# Access Compliance Report

## Public Rights-of-Way

### (Curb Ramps)

Intersection ID: 10031762	Main Street: MIDWAY_PARK_DR	Cross Street: N/A	Location: E
ADA ID: A82D6C7EB9DE	Ramp Type: Perp	Initial Pass/Fail: Fail	Overall Compliance: No
Severity Score: 12.5			
Codes/Mitigation Info/Possible Solution		Field Measurements/Component Compliance

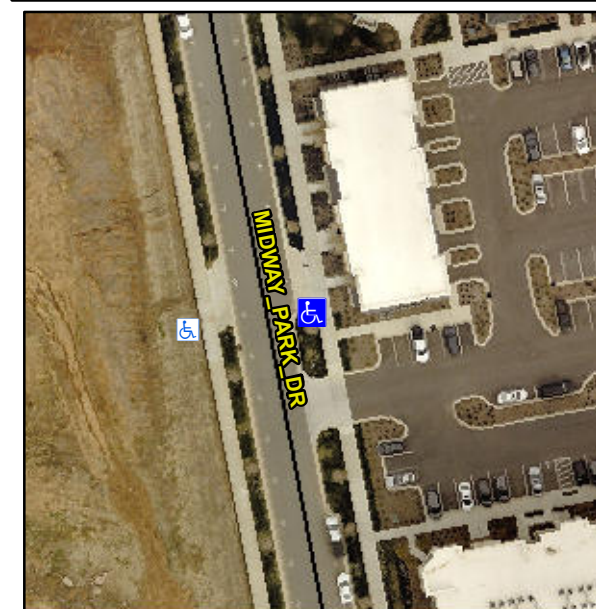
**Remove & Replace Entire Ramp.**

**R304.2.2**

Compliance	Description	Data	Compliance	Description	Data
N/A	Ramp Length (in)	50.0	No	Ramp Slope (%)	8.4
Yes	Ramp Width (in)	58.5	Yes	Ramp XSlope (%)	1.2
N/A	Flare Type LT	N/A	N/A	Flare Type RT	N/A
N/A	Flare Slope LT (%)	N/A	N/A	Flare Slope RT (%)	N/A
N/A	Flare Traversable LT?	N/A	N/A	Flare Traversable RT?	N/A
N/A	Landing Length (in)	N/A	N/A	DWS Provided?	N/A
N/A	Landing Width (in)	N/A	N/A	DWS Contrast?	N/A
N/A	Landing Slope (%)	N/A	N/A	DWS Length (in)	N/A
N/A	Landing X Slope (%)	N/A	N/A	DWS Full Width?	N/A
N/A	Landing Curb? (Y/N)	N/A	N/A	DWS Offset (in)	N/A
N/A	Shared Landing?	N/A			
N/A	Gutter Ponding?	N/A	N/A	Gutter Slope (%)	N/A
N/A	Gutter Lip Ht (in)	N/A	N/A	Gutter X Slope (%)	N/A
N/A	Painted X Walk1?	No	N/A	Painted X Walk2?	N/A
	X Walk 1 Direction	To W		X Walk 2 Direction	N/A
N/A	X Walk 1 Width (in)	N/A	N/A	X Walk 2 Width (in)	N/A
	X Walk 1 Slope (%)	2.4		X Walk 2 Slope (%)	N/A
	X Walk 1 X Slope (%)	1.1		X Walk 2 X Slope (%)	N/A
